# Trewirgie Junior School New Classroom Block

Tender Amendments 4-8

Trewirgie Junior School

October 2019

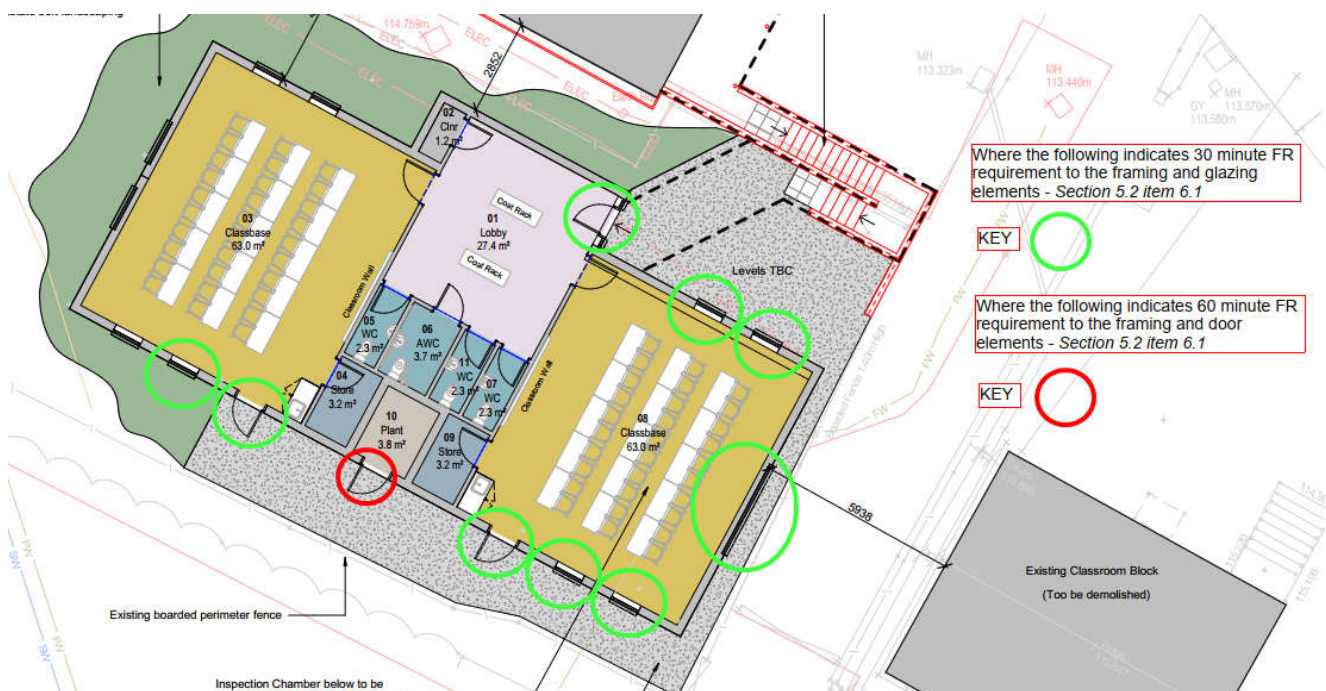
**Q** – External windows and doors, the spec states “Doors/Windows adjacent to external escape routes to be fire resisting construction including glazing”. Can you confirm you are asking for some frames to be fire rated ? If so could you please clarify which frames as there is an enormous price difference for fire rated aluminium.

**A** – Please see the annotated drawing extract below. Those indicated windows and doorsets should be supplied with 30 minute fire rating. The solid plantroom doorset should be supplied with 60 minute fire rating.
